RECALL CAMPAIGN BULLETIN

NTB14-006

VOLUNTARY SAFETY RECALL CAMPAIGN 2012 – 2014 FRONTIER CIRCUIT BREAKER

CAMPAIGN ID #: PC259

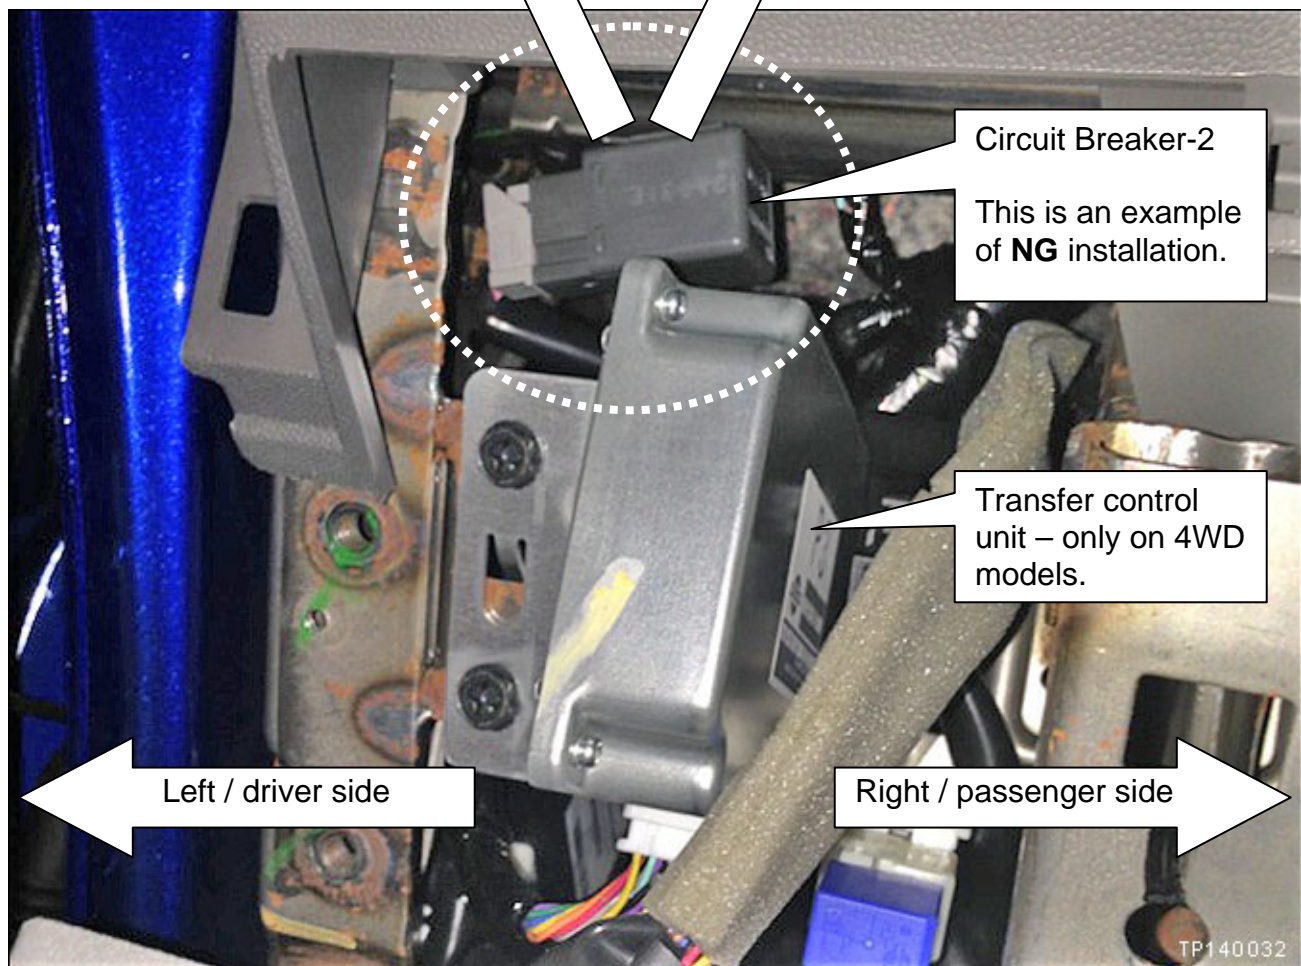
9. Inspect the orientation/installation of Circuit Breaker-2.

OK: If it is installed as shown in Figure 6, no further action is needed.

NG: If it is installed as shown in Figure 7, continue with this procedure.

Figure 11

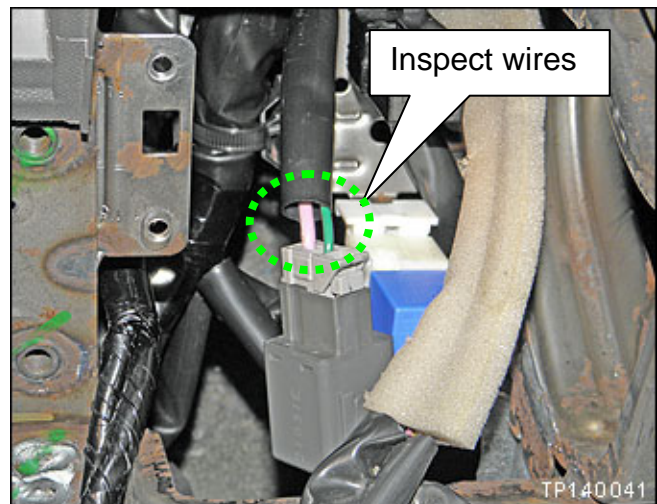
12. Inspect the wires at the Circuit Breaker-2 connector (see Figure 11).

If wire insulation has trauma (rubbed, chaffed):

- a. Cover the trauma area with electrical tape.
 - Take care not to bend the wires excessively to avoid breaking the wire core.
- b. Go to the next step.

Figure 12

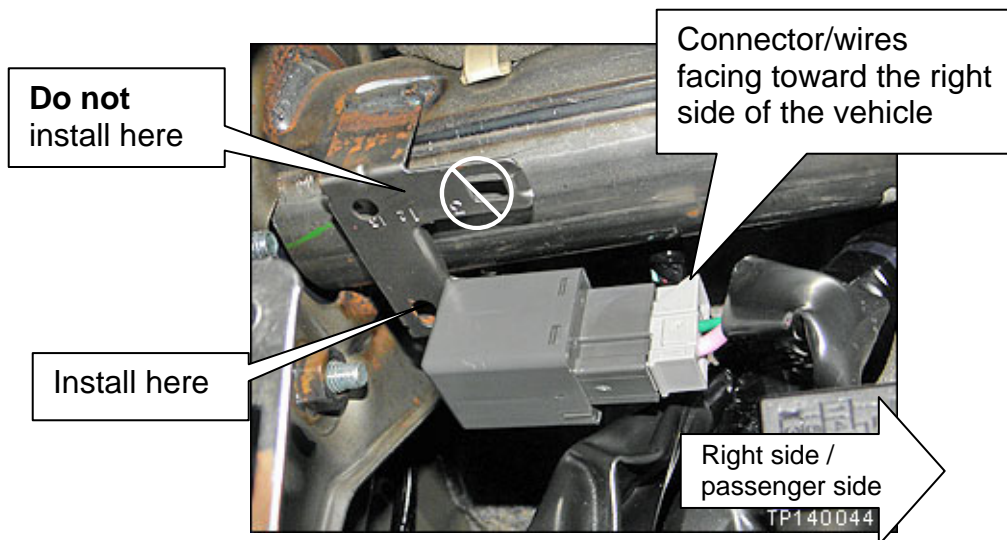
13. Reinstall Circuit Breaker-2 as shown in Figure 12.

- **Make sure connector/wires are facing towards the right side of the vehicle as shown.**
- **Make sure Circuit Breaker-2 is installed/positioned on the bracket as shown.**
